RESOLUTION SETTING HEARING ON REQUEST FROM THE PINNACLE ON FLEUR, LLC FOR APPROVAL OF PUD FINAL DEVELOPMENT PLAN FOR “PINNACLE ON FLEUR” FOR PROPERTY AT 2710 FLEUR DRIVE

Communication from the City Plan and Zoning Commission advising that at their June 4, 2020 meeting, the following action was taken regarding a request from Pinnacle on Fleur, LLC represented by William Kimberly (officer) for review and approval of a PUD Final Development Plan "Pinnacle on Fleur" on property located at 2710 Fleur Drive, to allow development of 20 household units within three (3) Row Type Buildings in accordance with the approved PUD Conceptual Plan requirements.

PUD FINAL DEVELOPMENT PLAN
PINNACLE ON FLEUR
Sheet 1 of 4

(UNIT B)-END-RIGHT-EAST - FLEUR DR
LEFT ELEVATION (CLUSTER 7)

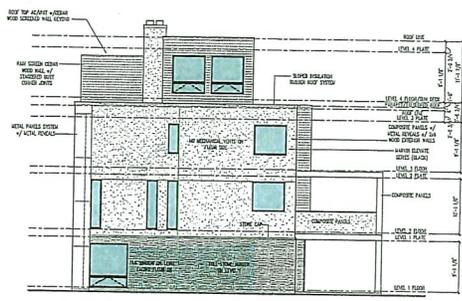
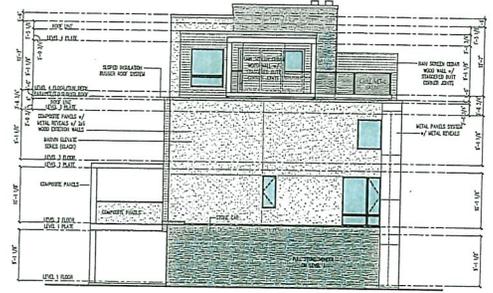
The PUD Conceptual Plan Amendment required that the end facade of the units closest for Fleur Drive is required have a separate prominent pedestrian entrance either from the garage or unit that would have a walkway to the private drive. This entrance is required to have an awning reflective of the building design. This is consistent with other Row House Type end facades in other developments when the main entrances of the units have not faced a public street but rather a private drive. The submitted plan does not provide for elements and any approval of the PUD Final Development Plan must be subject to meeting the requirements of the PUD Conceptual Plan as amended.

Provision of the required end unit elevations for facades of the units closest for Fleur Drive with a separate pedestrian entrance either from the garage or unit that would have a walkway to the private drive. The entrance shall be defined with a design appropriate awning or cover to the satisfaction of the Planning Administrator.
